IDAHO POWER COMPANY'S

2017 Integrated Resource Plan

Docket LC 68

SIERRA CLUB'S FINAL COMMENTS

Figure 1. IPC forecasted market energy prices and Bridger Unit 4 production costs

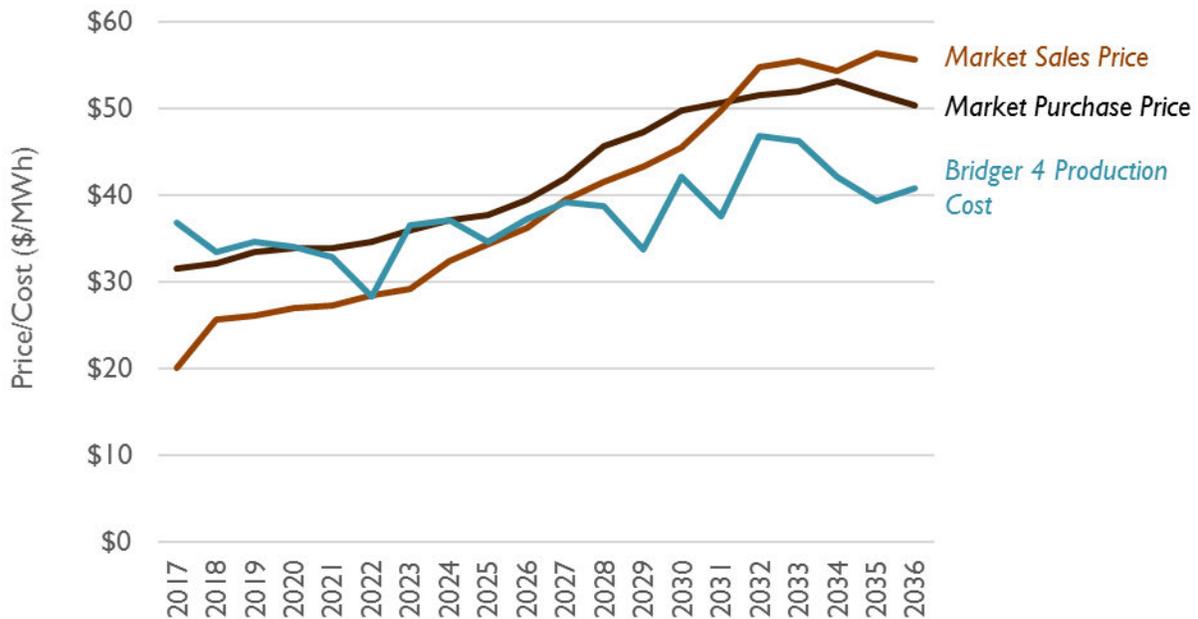
IPC devoted a section of its reply comments to the claim that “the Jim Bridger units remain economic resource options.”²⁰ However, IPC did not provide any evidence to support this claim. In contrast, Sierra Club’s opening comments demonstrate that IPC’s own modeling indicates that, even under assumptions that are unreasonably favorable to the Bridger plant, neither Bridger Unit 1 nor Bridger Unit 2 is an economic resource.²¹ Since IPC’s IRP modeling did not contain any information regarding future fixed costs at Bridger Units 3 or 4, it is not obvious what IPC’s modeling would show regarding the long-term economic status of these units. Nonetheless, IPC’s files show that, over the short term, Bridger Units 3 and 4 are both expected to incur net operational losses, without accounting for any fixed costs. Figure 1 shows that for nearly every year between now and 2025, IPC forecasts that Bridger Unit 4 will incur variable production costs that are greater than the average price IPC will receive for energy it sells on the market. The same general picture holds for Bridger Unit 3.
